Re: SEC Docket No. 2015-04 – Application of Public Service Company of New Hampshire d/b/a Eversource Energy for a Certificate of Site and Facility for the Construction of a New 115 kV Transmission Line from Madbury Substation to Portsmouth Substation (Seacoast Reliability Project)

**PRE-FILED DIRECT TESTIMONY OF MICHAEL LAWRENCE
MICHAEL LAWRENCE ASSOCIATES, PLC**

NH Seacoast Reliability Project - Aesthetic Analysis Review
Plan of Project Route
Michael Lawrence Assoc. Landscape Architects Essex Junction, Vermont 05452

Photo #37—LOCATION J2. (UNH—Main Street Overpass) looking south parallel with proposed project—October, 2016—55 mm eq.

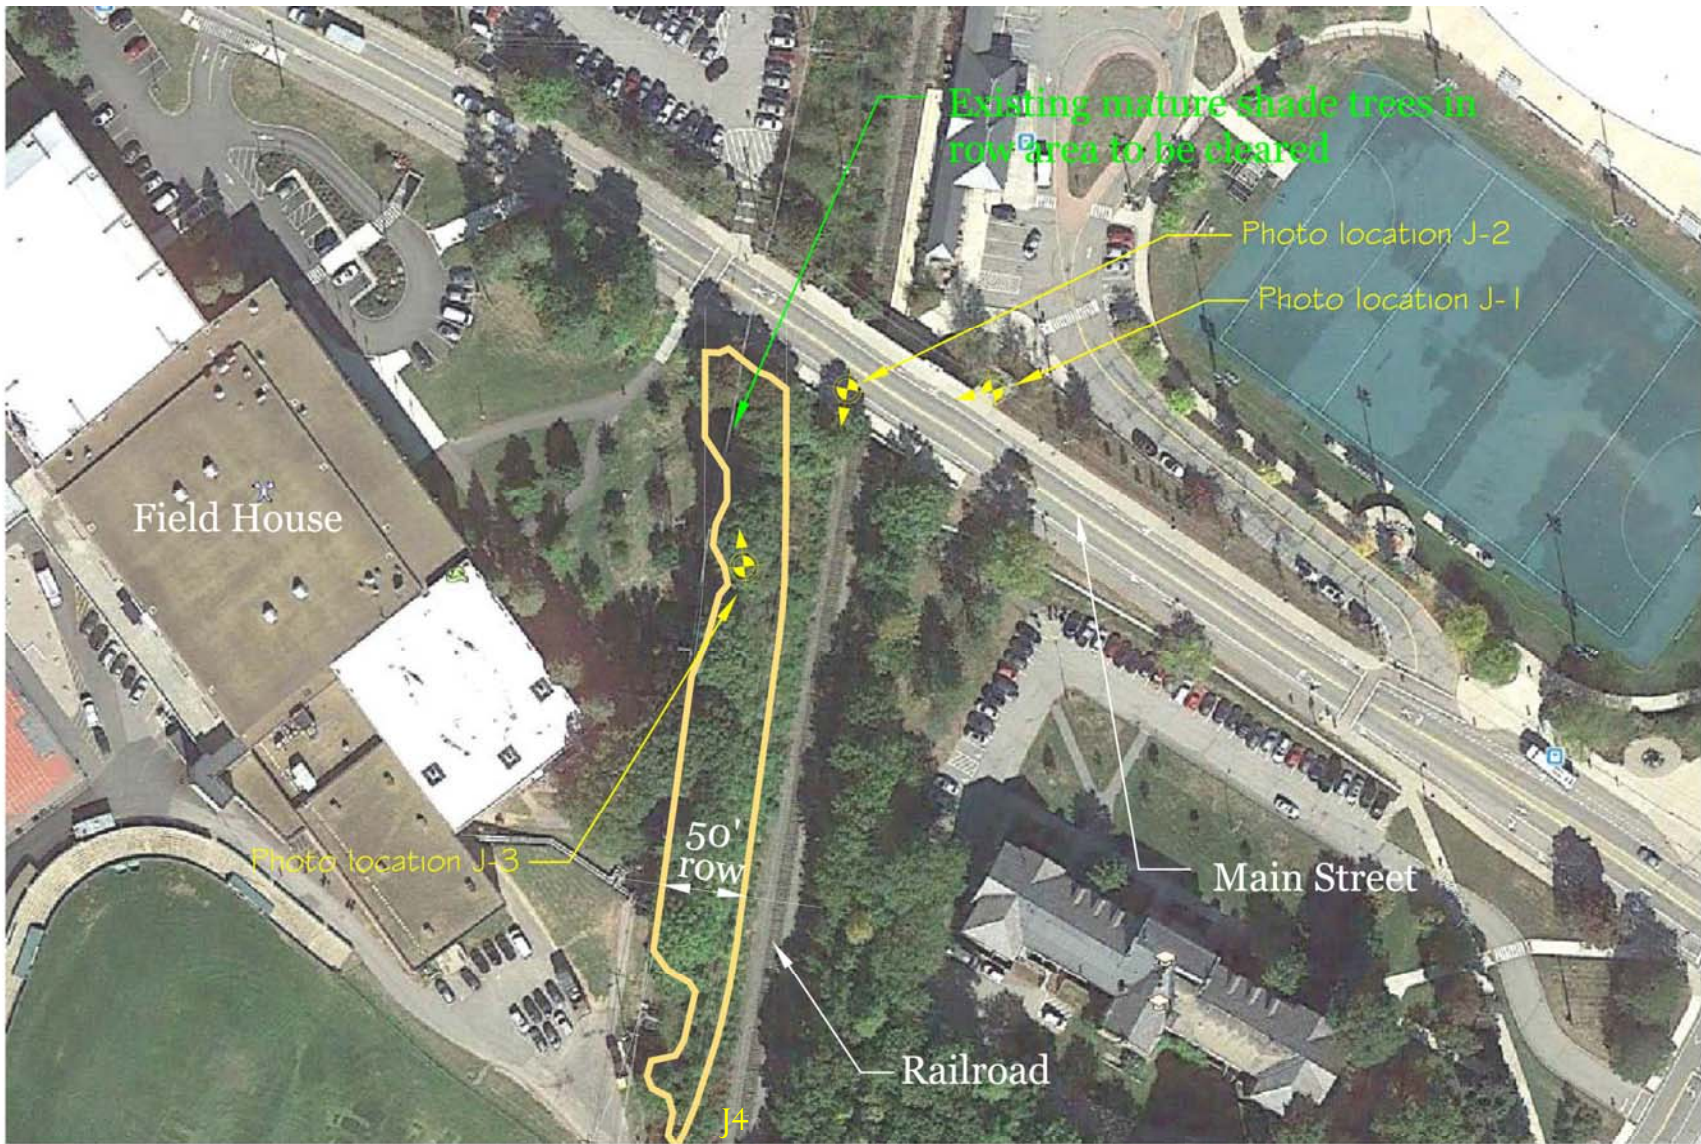
running south from Main Street for about 475 ft. about 50 ft. beyond the west side of the railroad ROW. The line is underground here. The Project ROW angles towards the railroad ROW and joins it approximately 150 ft. south of Main Street.

The Landworks report did not include a photosimulation from this point to indicate the impact of clearing, and the visual effect of the trees that are to remain in the 50 ft. x 150 ft. triangle between the railroad and project ROW. This remaining vegetation is presently the east edge of a contiguous grove of mature trees. The environmental map illustrates the 50 ft. wide project ROW cleared along its

Photo #46—LOCATION L-2. (UNH—Gables North Parking) looking south along proposed project—November, 2016—panorama

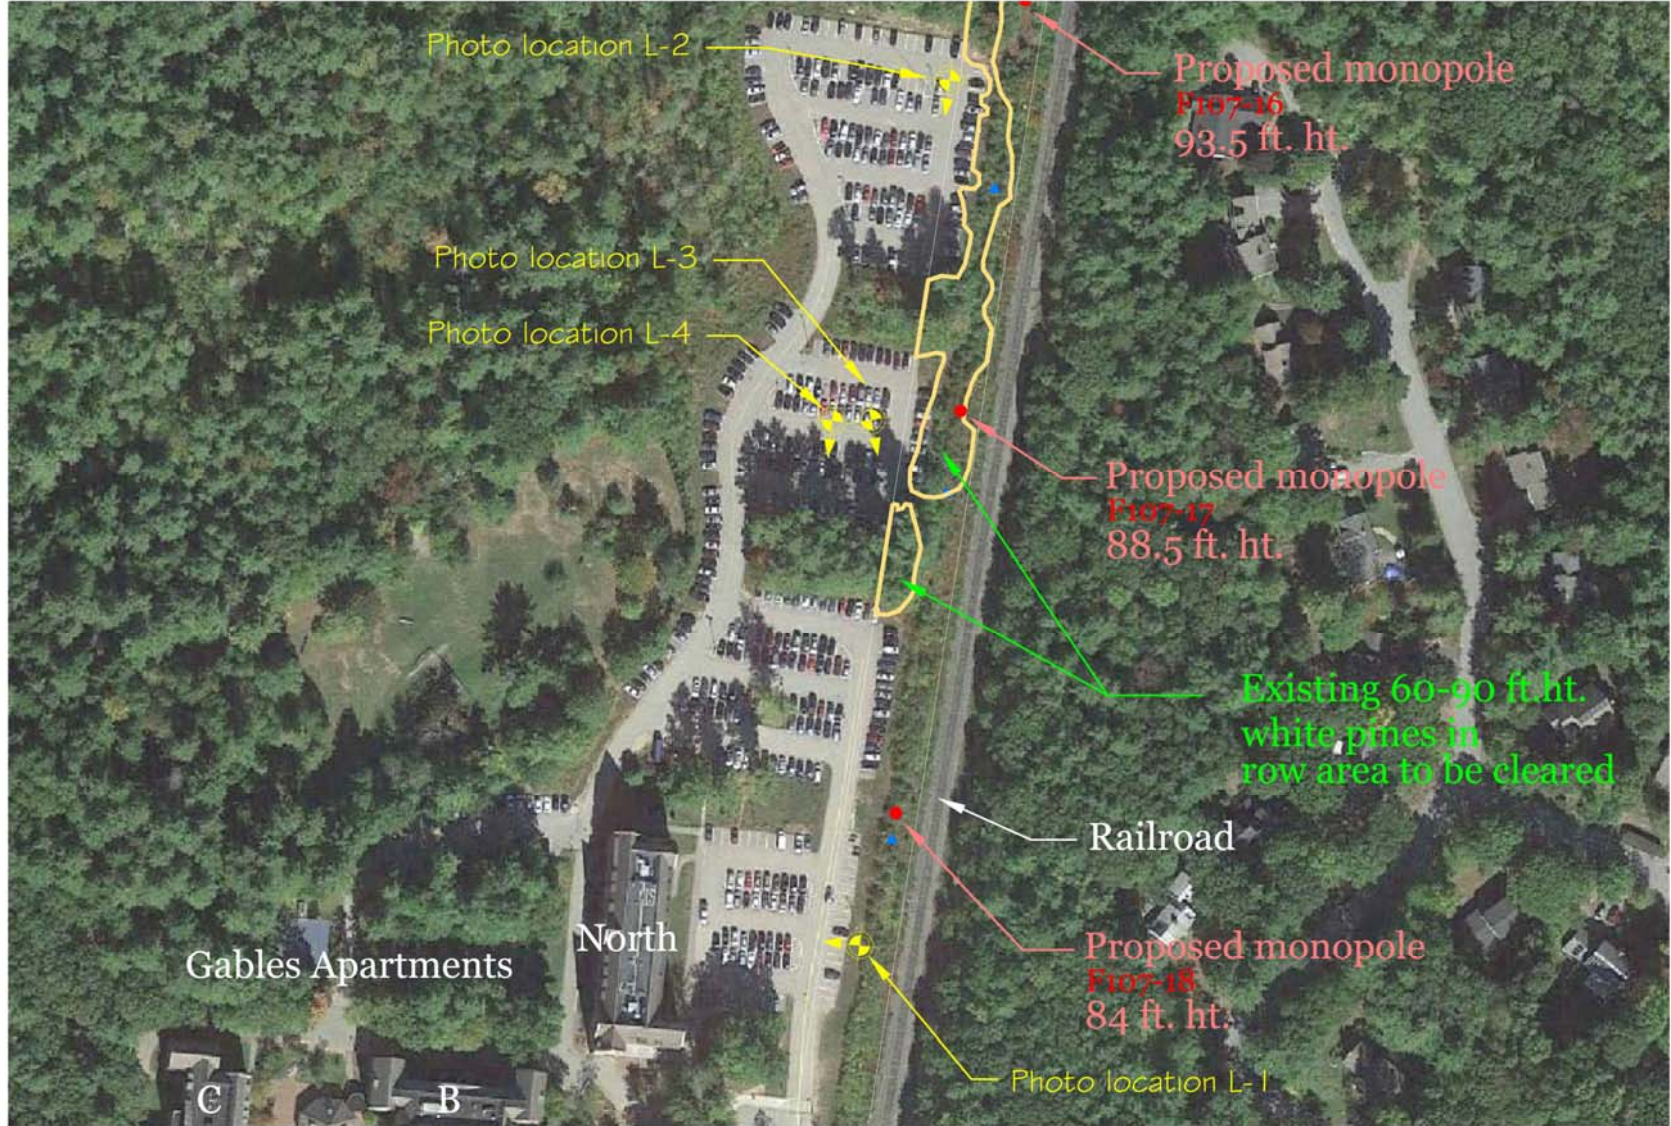
Parking for the five-building Gables residential complex is located in four lots, the first (southernmost) lot in a 200 ft. wide area between the northernmost Gables building and the railroad and the rest in lots to the north.

The southernmost lot holds 75 vehicles. Moving north, the lots accommodate 110, 110 and 150 vehicles respectively. The access drive runs on the east side of the first and second lots, crosses the second lot, then turns and accesses the northern two lots from the west.

NH Seacoast Reliability Project - Aesthetic Analysis Review
 M. Route 4 Crossing
 Clearing diagram with tree and pole heights

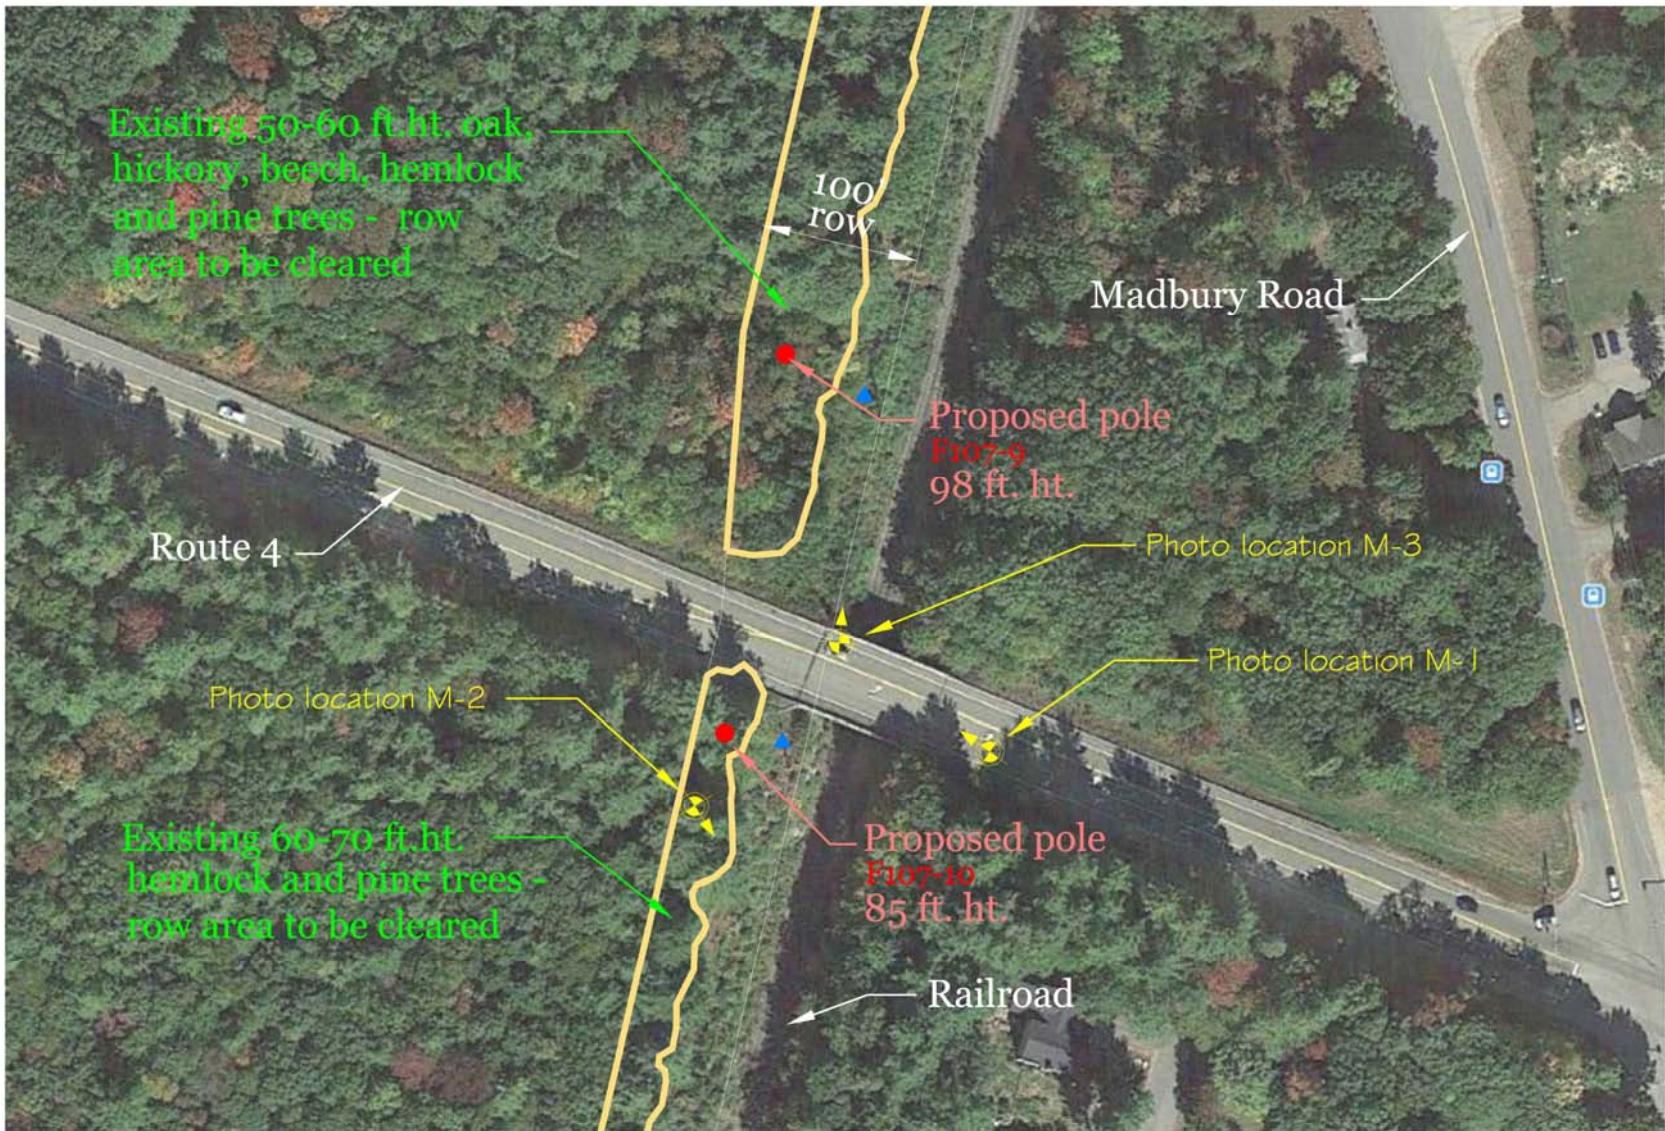
The transmission line crosses Route 4, a limited access, east-west highway north of Durham just west of the bridge over the Boston and Maine Railroad. This section of highway runs for about 1.5 miles between the Madbury Road intersection and the West Main Street interchange. The character of the road is rural, mostly lined with mature woodlands, interrupted briefly with wetlands and farmland. There is no development along this stretch of Route 4. This section of road has scenic value.

The existing line consisting of 35-40 ft. high wood poles runs in an 80-90 foot wide corridor along with the B&M tracks formed by walls of large white pines. Present line views both south and north of Route 4 are imperceptible due to the relatively narrow opening in the woods along the road.

Environmental Map 2/28 locates the edge of the current pines 15 ft. west of the existing transmission line. It shows new poles south of Route 4 running parallel with the tracks in the line of the existing poles. New poles north of Route 4 are located about 50 ft. west of the current poles.

The plan shows vegetation cleared in an area varying between 25 and 40 ft. wide by over 2,000 ft. long south of Rt. 4 and 60 ft. wide by 700 ft. to the north.
